# METROPOLITAN GOVERNMENT OF NASHVILLE AND DAVIDSON COUNTY

## STAFF RECOMMENDATION 2607 Oakland Avenue May 15, 2013

**Application:** Partial Demolition; New Construction—Addition; Demolition—  
Outbuilding; New Construction--Outbuilding; ~~Reduce Setback~~  
**District:** Belmont-Hillsboro Neighborhood Conservation Zoning Overlay  
**Council District:** 18  
**Map and Parcel Number:** 11704008300  
**Applicant:** Preston Quirk, Architect  
**Project Lead:** Sean Alexander, sean.alexander@nashville.gov

SITE PLAN

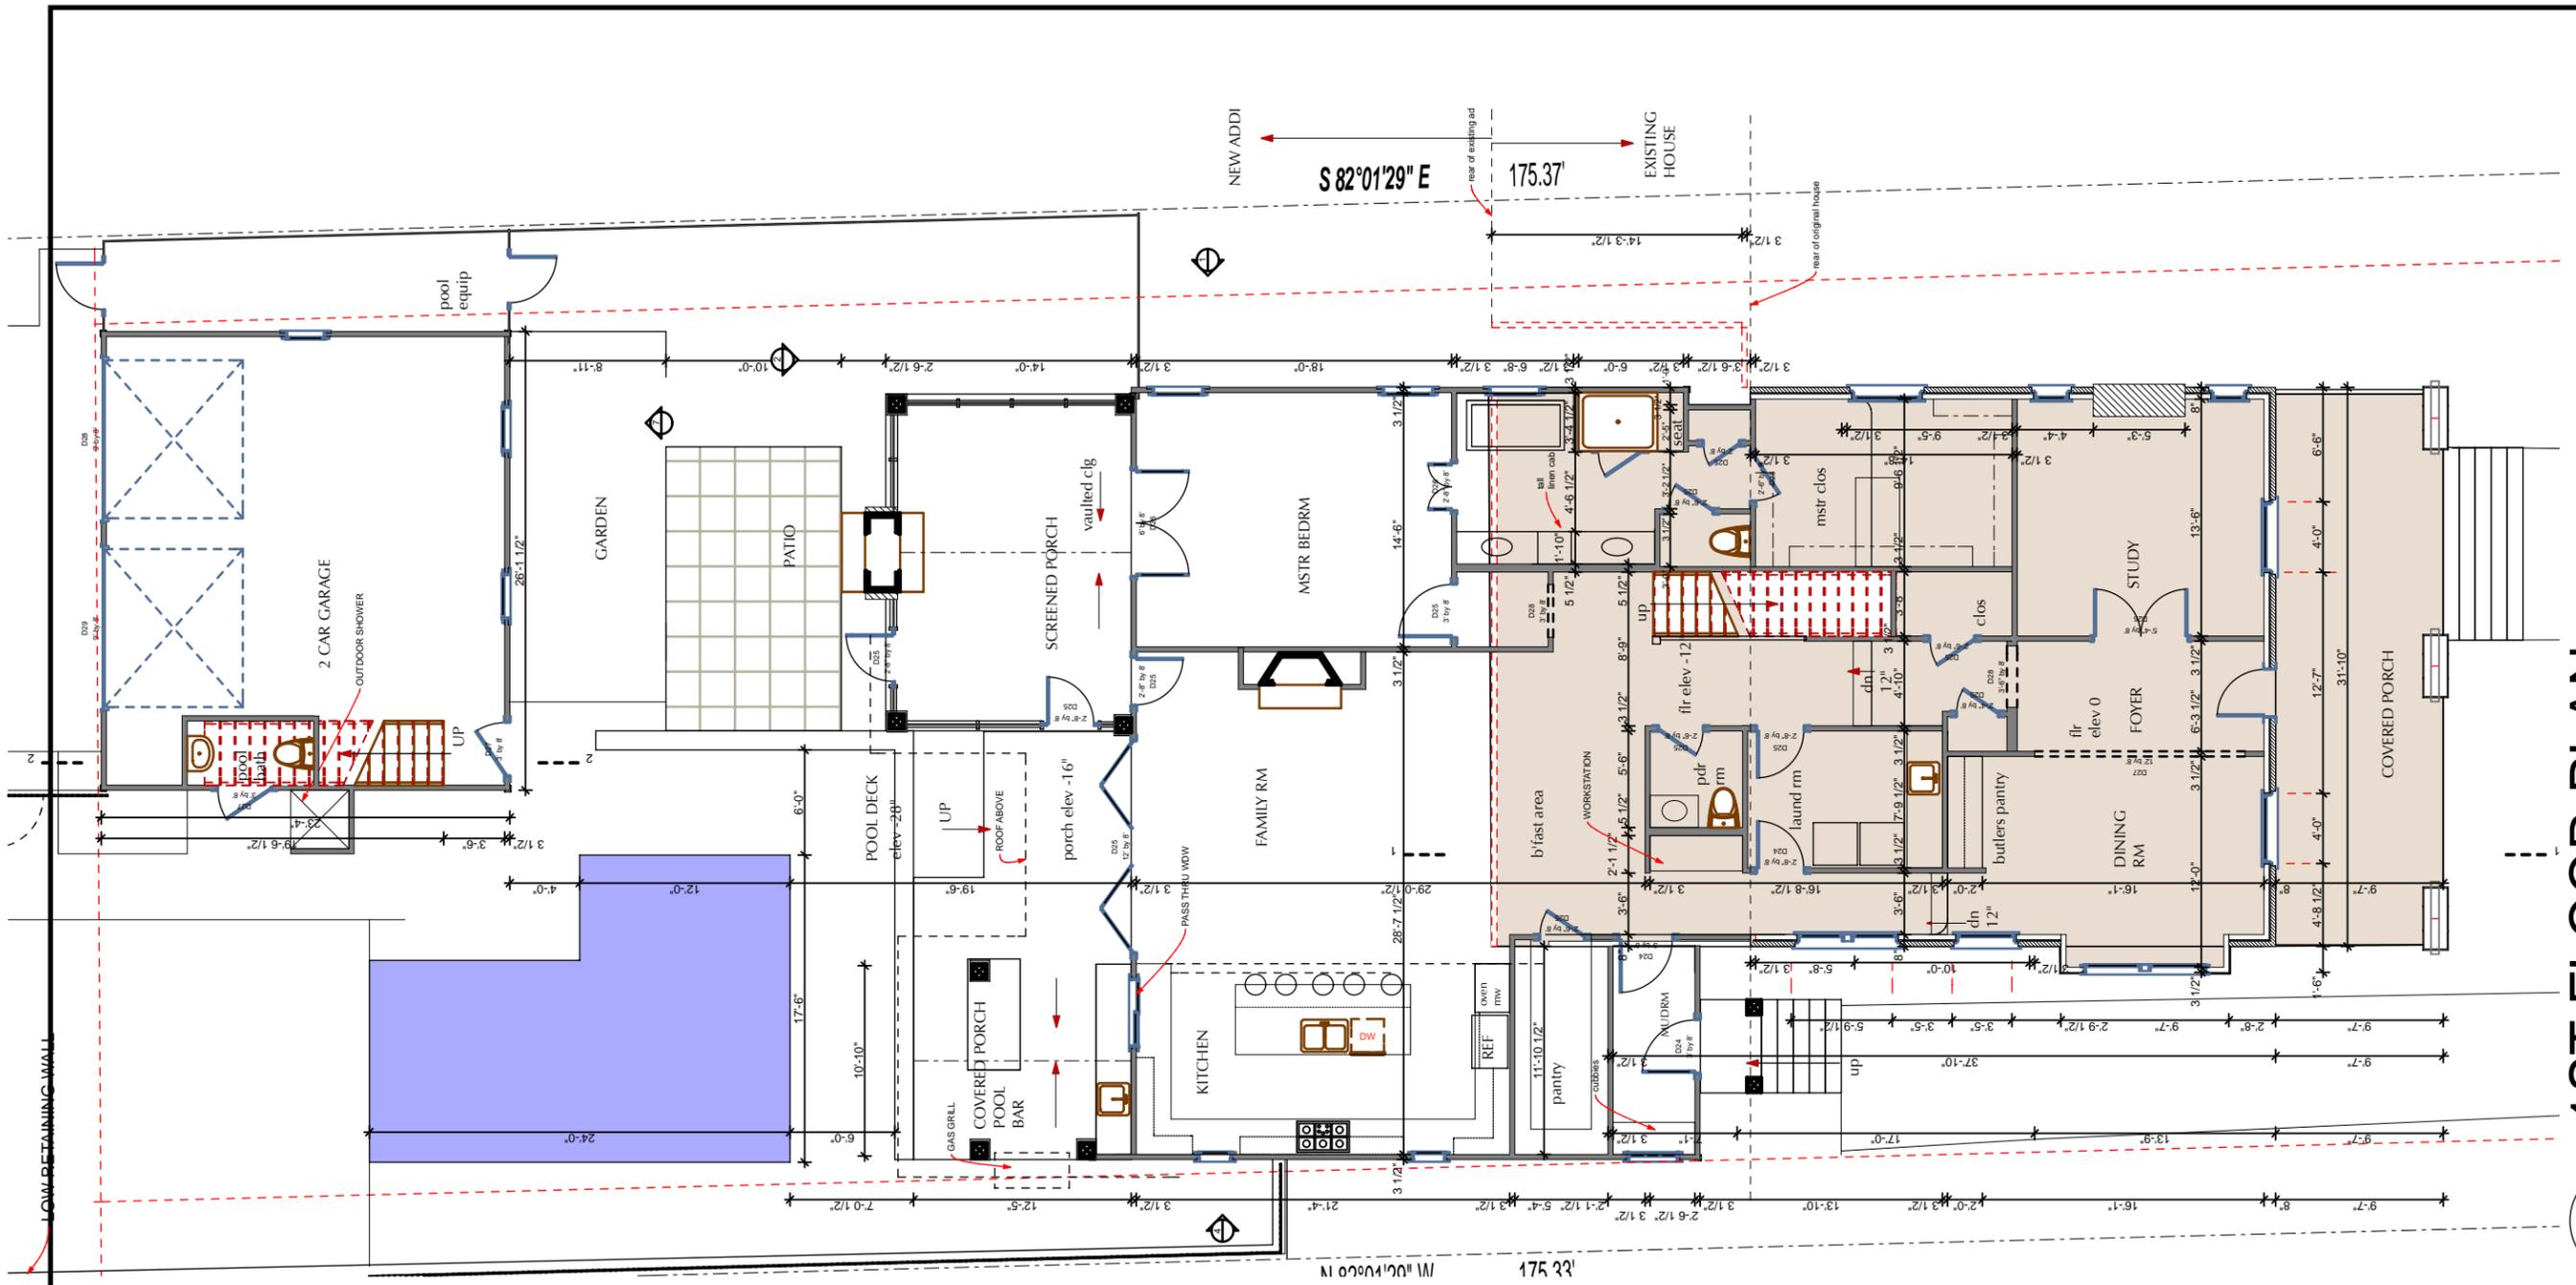
The outbuilding will be located behind the primary building, ten feet (10’) from the rear property line and five feet (5’) from the right side. This location is typical for that of historic outbuildings and meets the current bulk zoning setback requirements. [On initial inspection, Staff anticipated that a reduction of the rear setback would be required. After reviewing the plans, it was determined that the outbuilding meets the current bulk zoning setback requirements.]

**2** GAR FRONT ELEVATION  
SCALE: 1/8" = 1'-0"

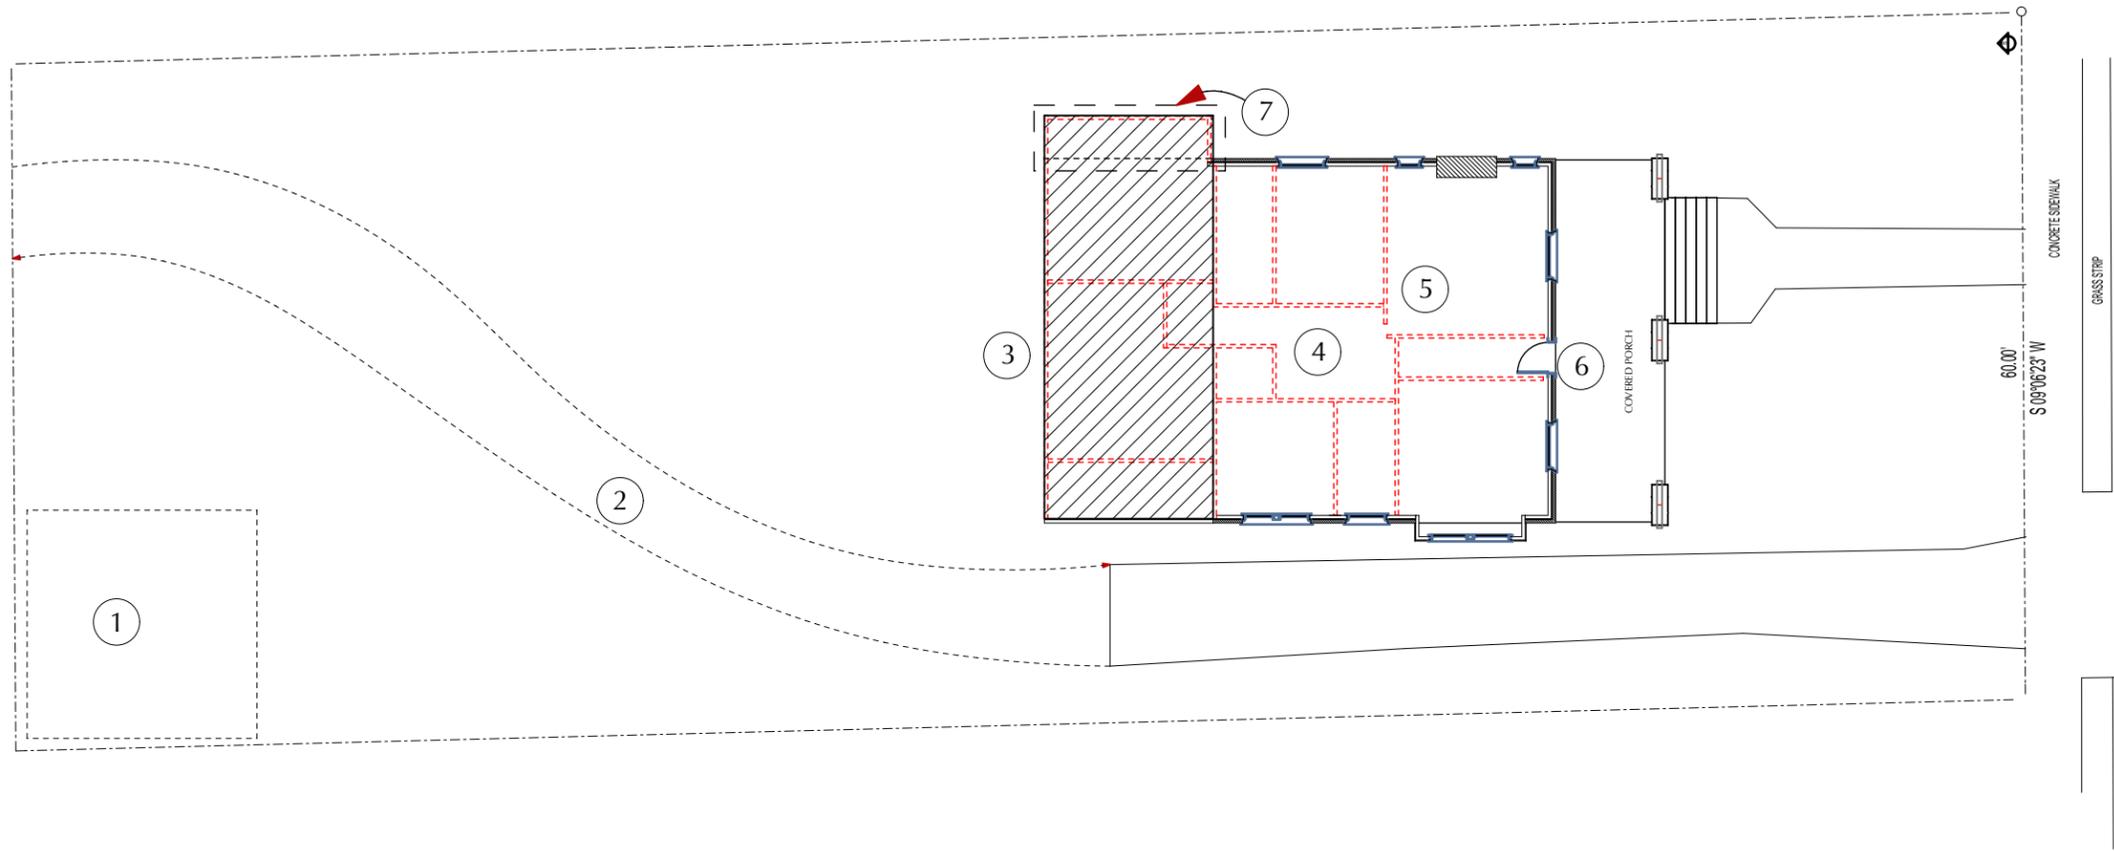
The proposed new outbuilding will be a two-car garage with a footprint of approximately six hundred, ten square feet (610'). The roof of the building will be a side-facing gable matching the pitch of the roof of the house. The outbuilding will have a ridge height of twenty-five feet (25'), which is three feet (3') shorter than the roof of the house and the eave height of the building will be fifteen feet (15'). Although the overall height of the building is subordinate to the house, the eave height is three feet (3') higher than the eaves of the house. Staff finds that this proportion is not appropriate for an accessory building, and recommends that the height of the outbuilding be lowered so that the eaves

match the eave height of the house. [Note – Staff does not recommend lowering the eaves only as that would make the roof pitch significantly steeper, which would not be appropriate.]

1. The height of the outbuilding be lowered so that the eaves match the eave height of the house; and
2. That a brick sample and the materials of the doors, windows, and trim be approved administratively.
